STAFF REPORT
COMMUNITY DEVELOPMENT DEPARTMENT

HEARING DATE: 5/7/2024
TO: Mayor & City Council
FROM: Sonya Allen, Associate Planner
208-884-5533
SUBJECT: FP-2024-0007
Biltmore Estates Subdivision No. 5
LOCATION: Generally located at the northwest corner of S. Kentucky Way and W. Harris St., in the northern 1/2 of Section 25, T.3N., R.1W.

Final plat consisting of 36 building lots and four (4) common lots on 11.81 acres of land in the R-4 zoning district for the fifth phase of Biltmore Estates Subdivision.

B. Final Plat (date: 3/11/2024)

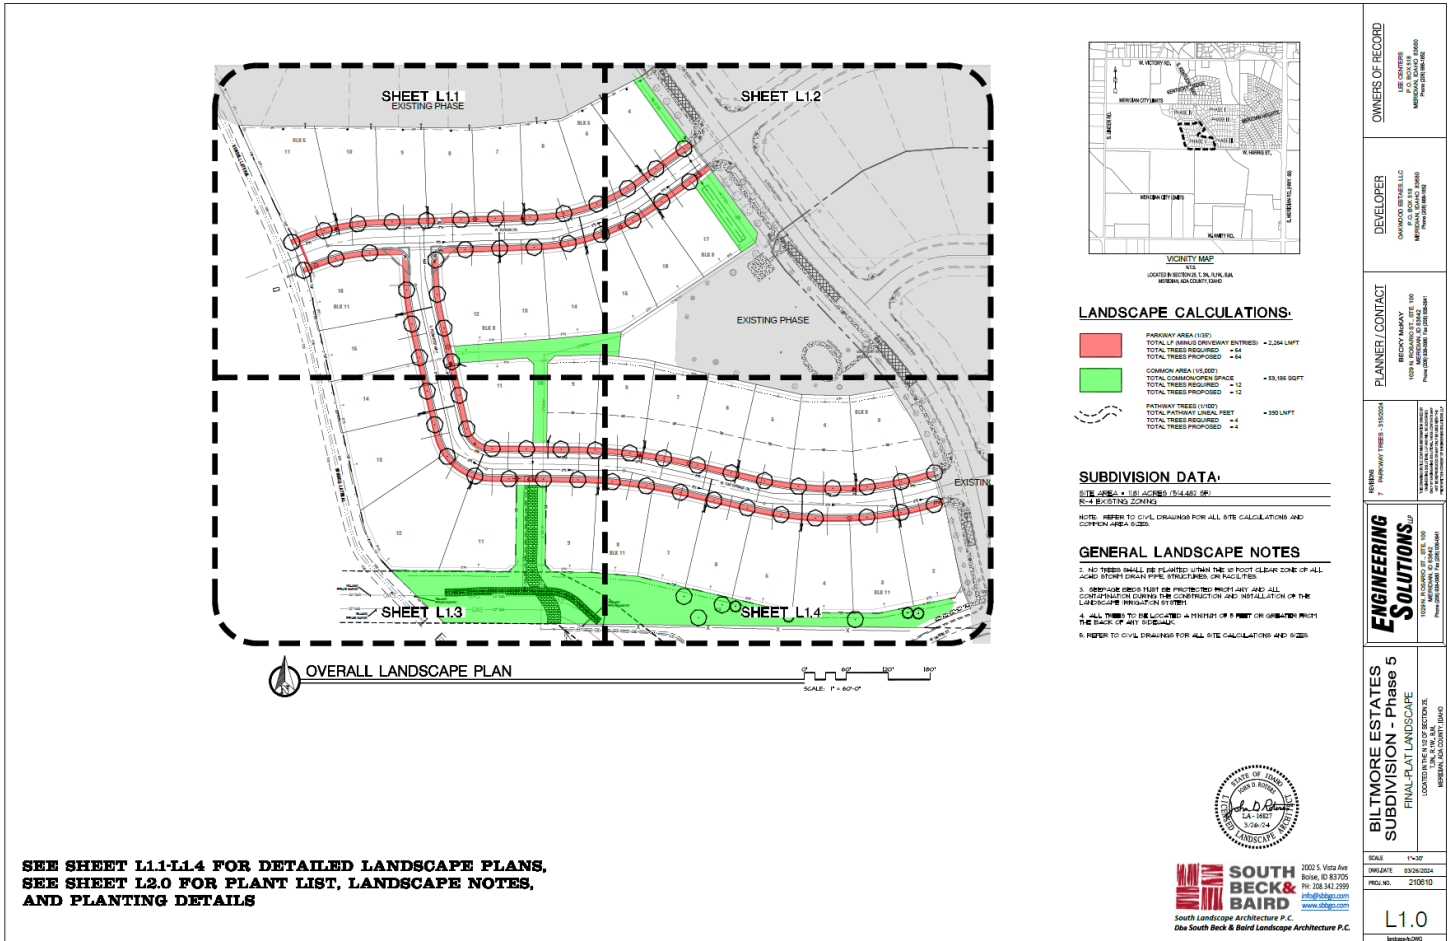
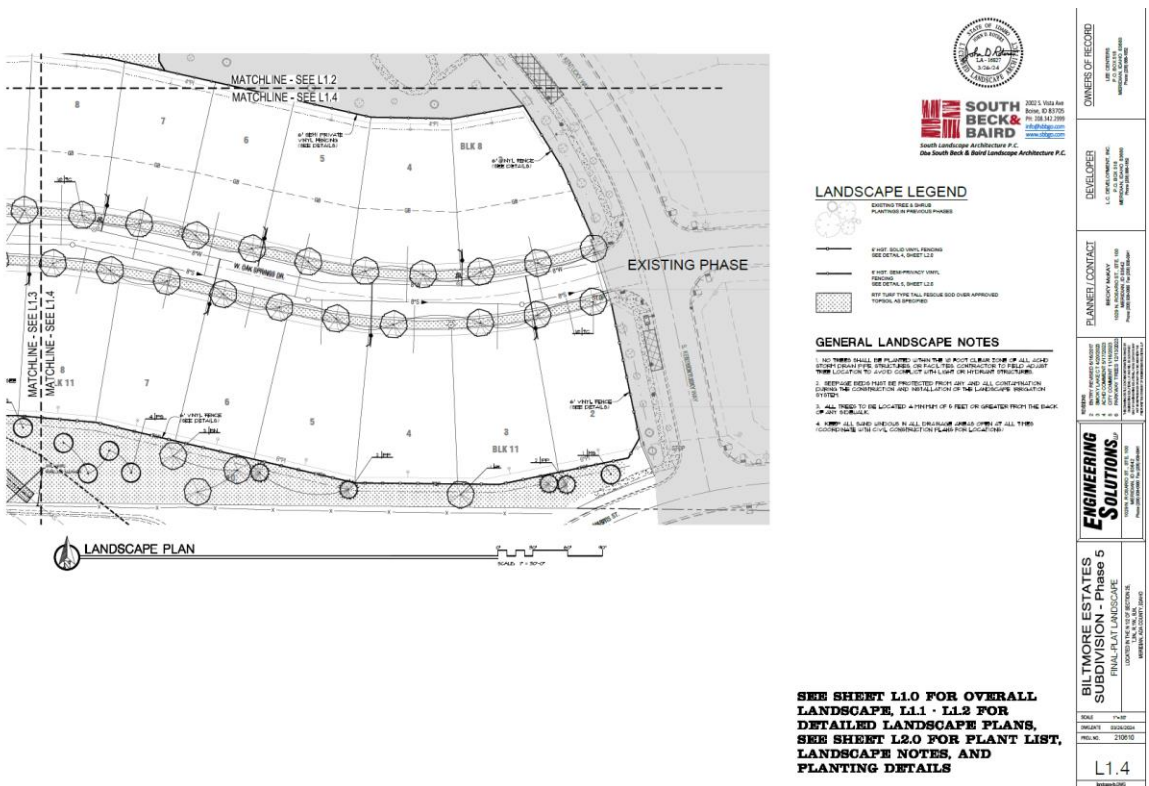
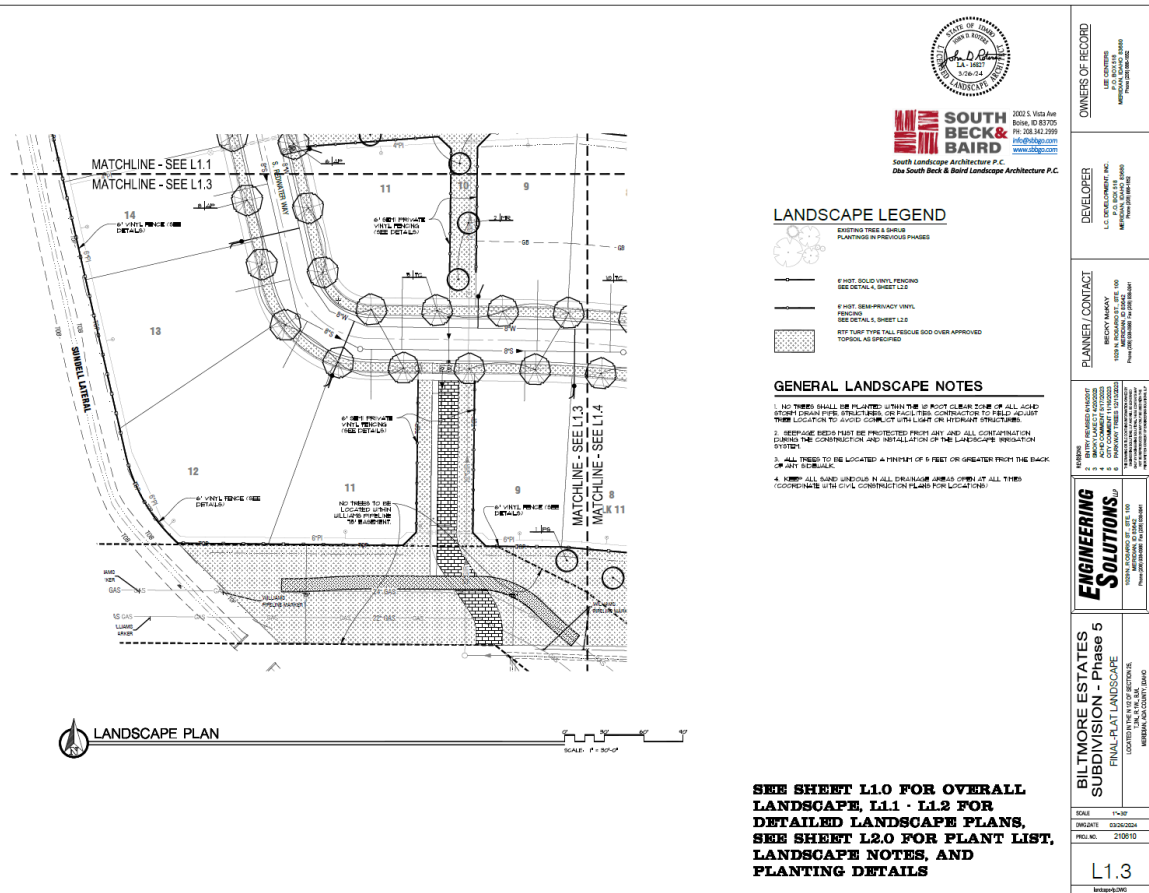
1. Applicant shall comply with all previous conditions of approval associated with this development [AZ-13-014 (Ord. #14-1594) – Victory South; PP-14-0004, Development Agreement Inst. #[114052420](#) – Biltmore Estates; A-2019-0366; [TECC-2021-0001](#)).
2. The applicant shall obtain the City Engineer's signature on the final plat by December 15, 2025; or, a time extension may be requested.
3. Prior to submittal for the City Engineer's signature, have the Certificate of Owners and the accompanying acknowledgement signed and notarized.
4. The final plat shown in Section V.B prepared by Engineering Solutions, LLP, stamped on 2/7/2022 by Clinton W. Hansen, shall be revised as follows:
 - a. Note #12: Include the recorded instrument number of the ACHD temporary license agreement.
 - b. Include the recorded instrument number of the ACHD permanent sidewalk easement in the Legend.

An electronic copy of the revised plat shall be submitted with the final plat for City Engineer signature.

C. Landscape Plan (date: 3/26/2024)

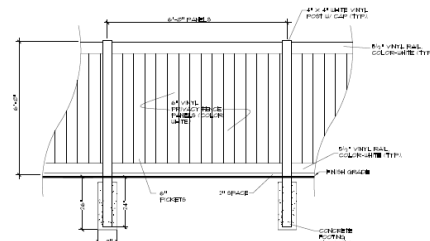
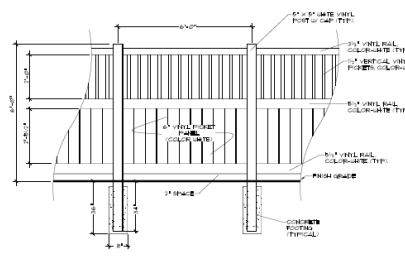
5. The landscape plan shown in Section V.C, dated 3/26/24, shall be revised as follows:
 - a. The total linear feet of parkways (excluding 26' for each driveway) shall be included in the calculations table along with the required vs. proposed number of trees.
